# ACTION MEMORANDUM

## Iron Mountain Road Addition Fort McClellan, Alabama

### **Responsiveness Summary**

ARMY RESPONSE TO COMMENTS PROVIDED BY MR. BUDDY COX, ALDOT

## Fort McClellan Anniston, Alabama Washington Tank Range Fan

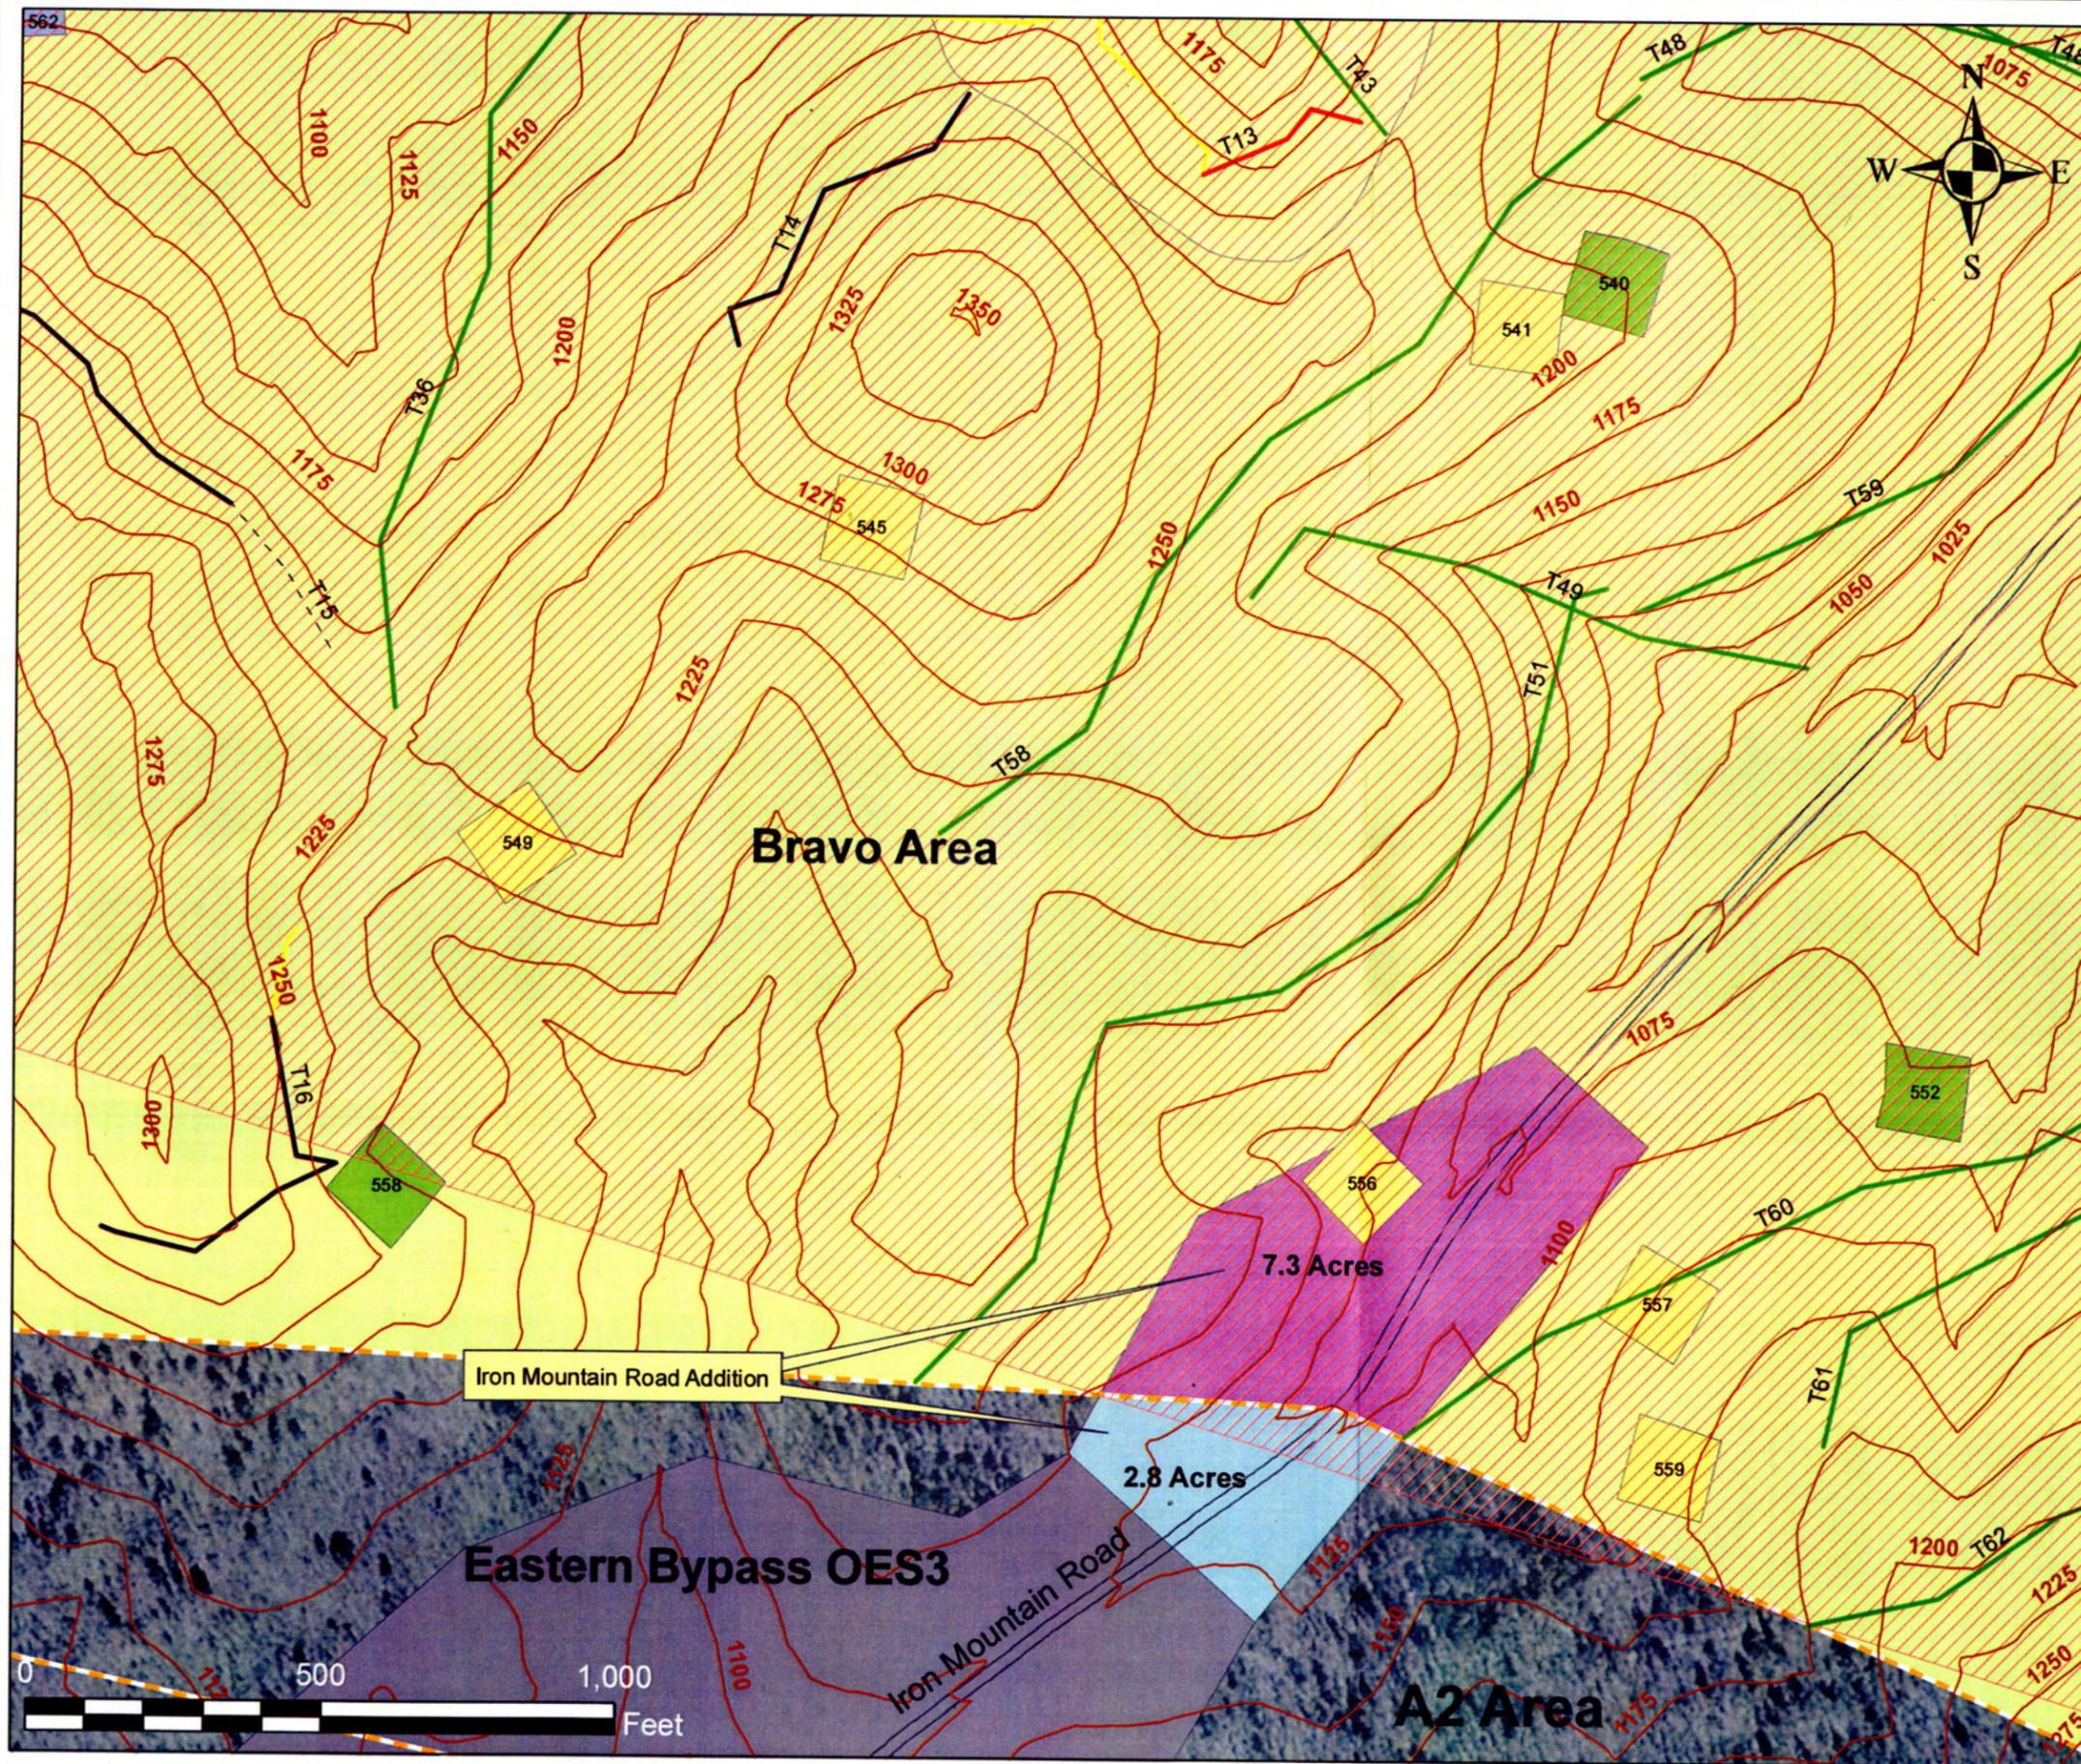
Section 4.2.6 also reports that the tank range fan, even though it covers the 11 acres, would not impact the area as the mountain would block shells from falling in this area. I question the validity of this comment, especially for the area east of Iron Mtn. road. Also, one can set the trajectory of a round to come in on the immediate back side of a mountain. It would seem likely that gunners would be required to practice this type of a scenario just to insure rounds could be placed on an enemy dug into the back side of a mountain.

It is true that this area is on the southern border of the range fan for the Washington Tank Range. The records do not have a lot of discussion about the use of this range. But, it is also true that the transects and grids in and near the Iron Mountain Road addition did not have MEC found. It is true that there are several hilltops that are 200-300 foot higher than the subject area between the Iron Mountain Road addition area and the presumed firing line. Tanks are operationally used as direct fire weapons, meaning they see the targets they fire at. This is why this was evaluated as a low risk.

Fort McClellan  
Anniston, Alabama  
Iron Mountain Road Addition  
Previous MEC Investigations  
(Grids and Transects)

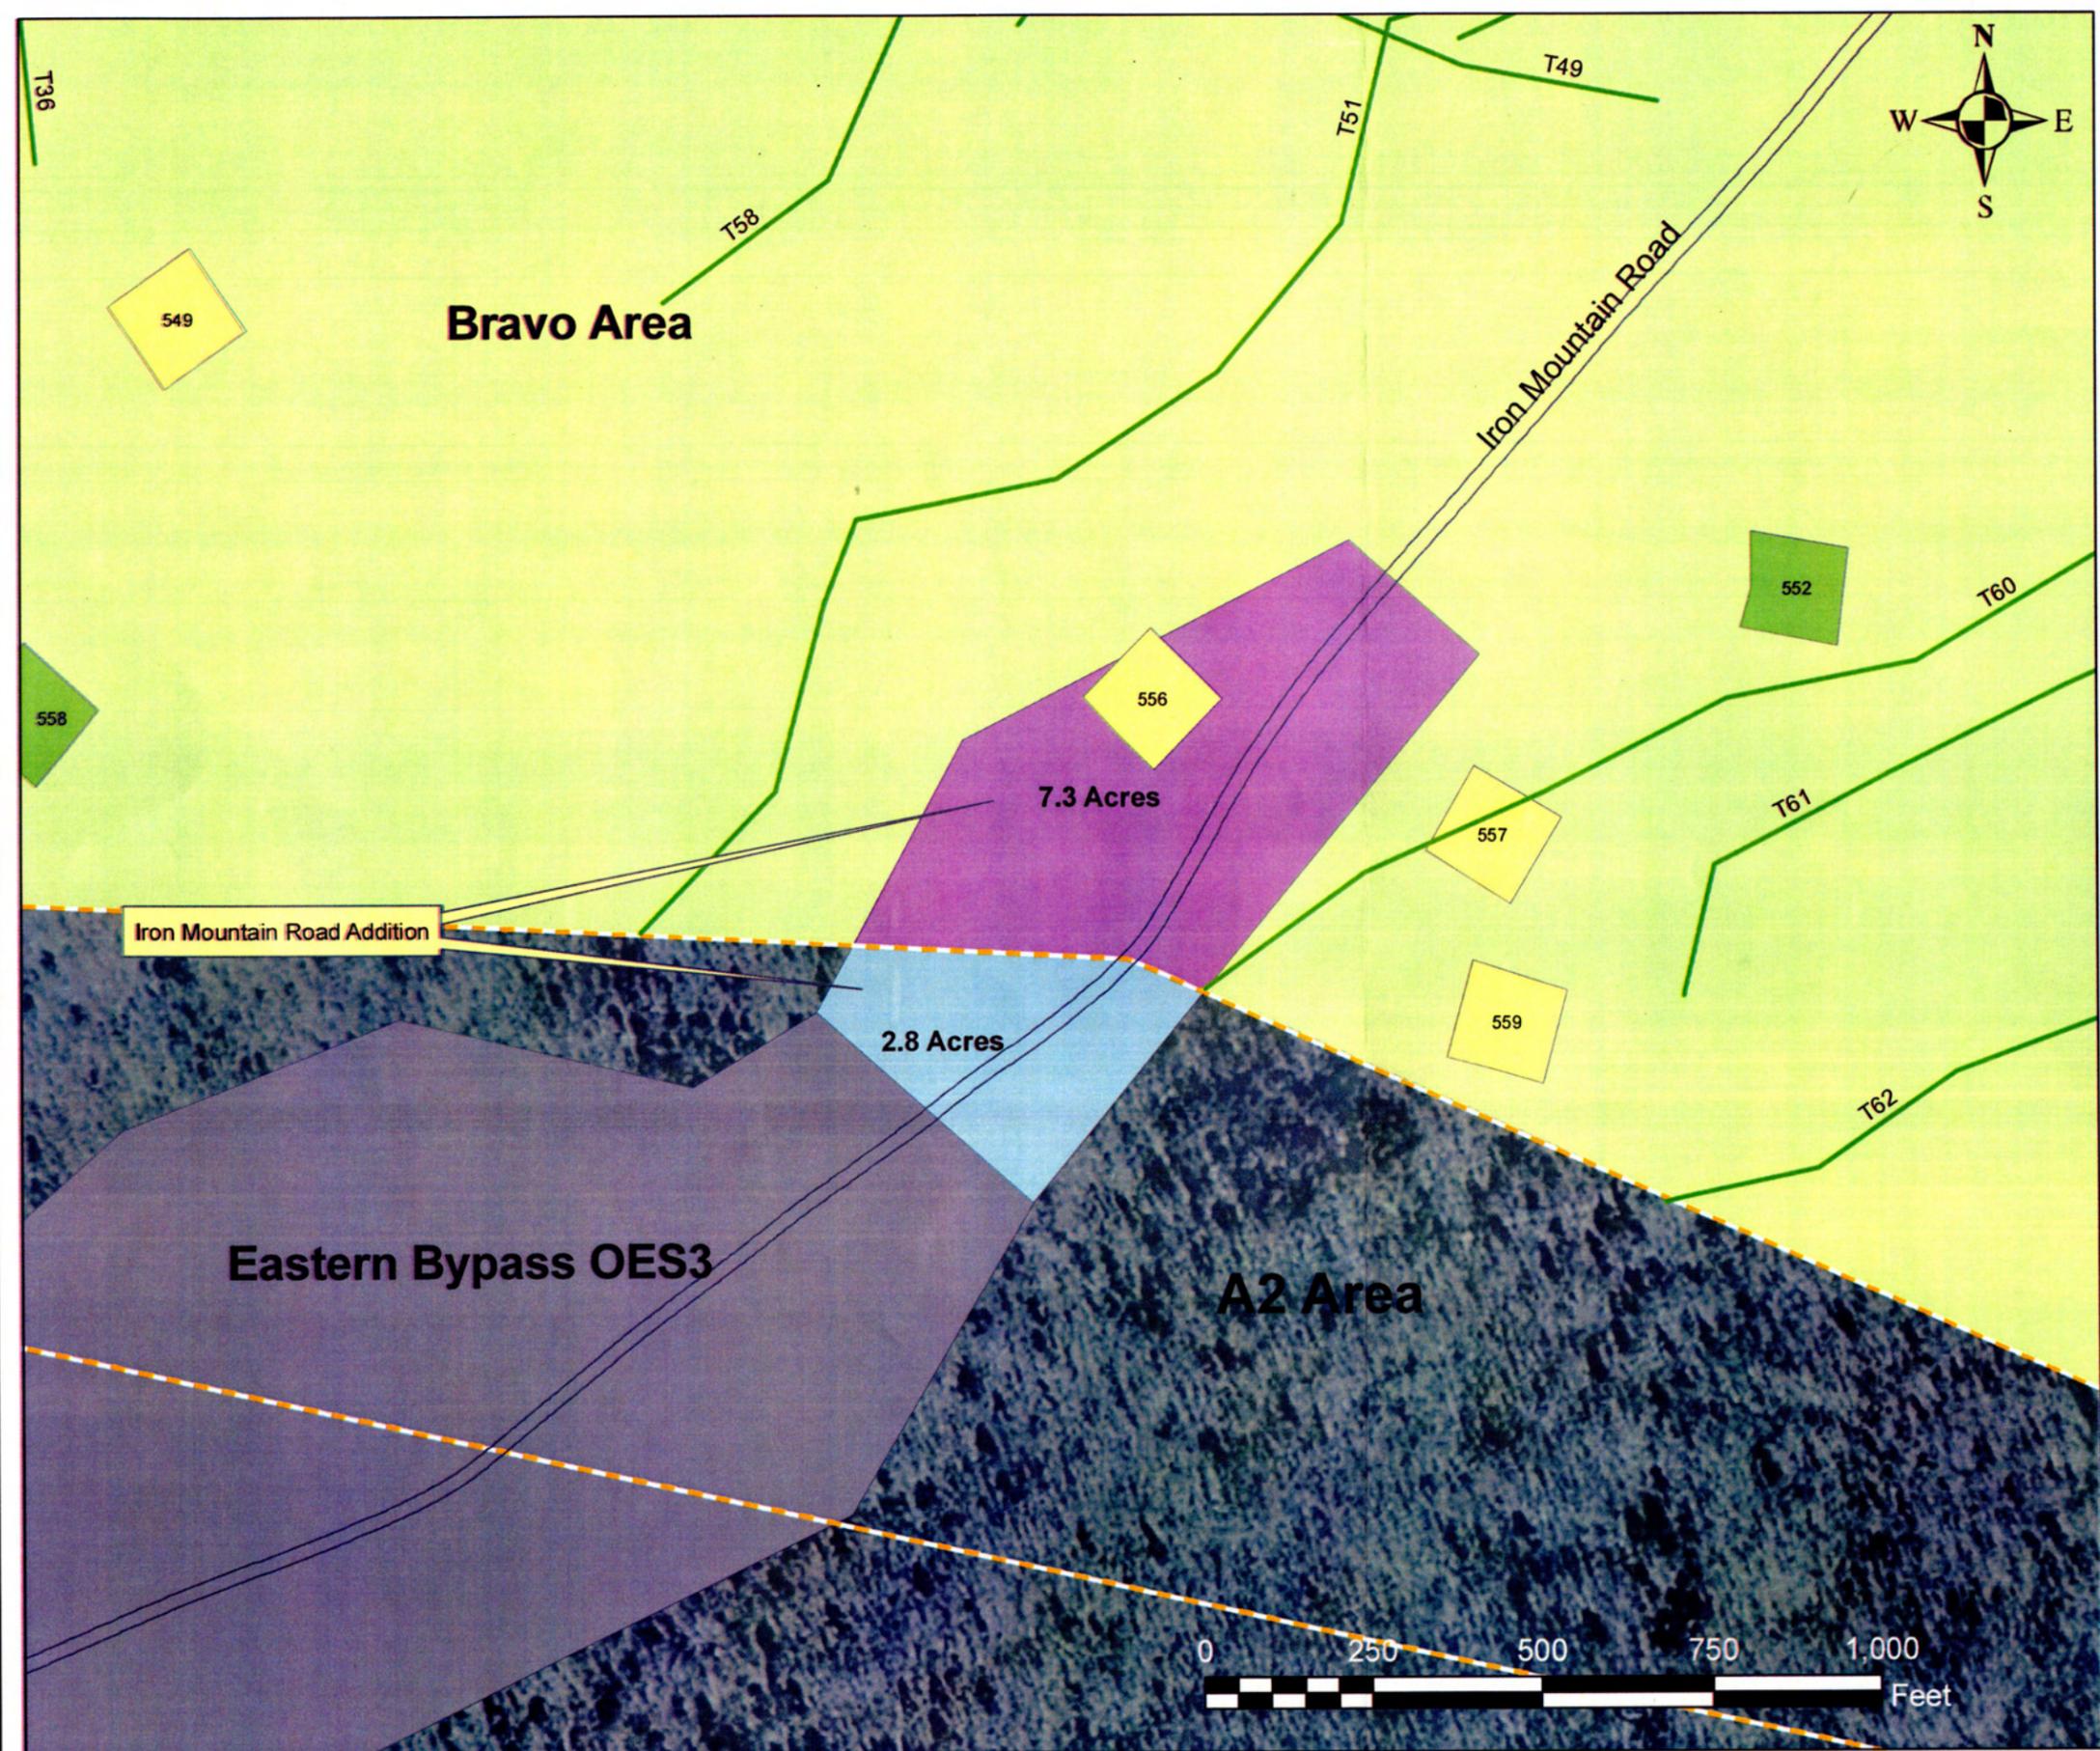
2. Section 3.1 states that Figure 3.1 shows grid and transect locations investigated. There are no transect lines. Note grid 556 shows a significant amount of debris. Was it on the surface or was it found with geophysical means? Section 3.3 again references transect lines on Figure 3.1. Section 3.3 also references transects T36, T49, T51, T58, T60, T61, and T-62 as being on Figure 3.1. The Figure 3.1 I have has no transect lines.

**RESPONSE:** Figure 3.1 of the final report dated July 2008 clearly shows transect lines in the Bravo Area. The Bravo Area transects cited bound the Iron Mountain Road addition area on the east, north and west. These transects were geophysically surveyed and investigated to resolve the anomalies. As stated in section 3.3 no Munitions and Explosives of Concern (MEC) were found. While only one grid (556) is located within the boundary of the Iron Mountain Road Addition, the three other grids cited (552, 557, 559) are within 400 feet of the subject area. All the grids mentioned had no MEC found. Debris in grid 556 was found at various depths from the surface to 4 inches. The debris that was found is indicative of a maneuver training area, not an impact area as noted in section 4.2.3.
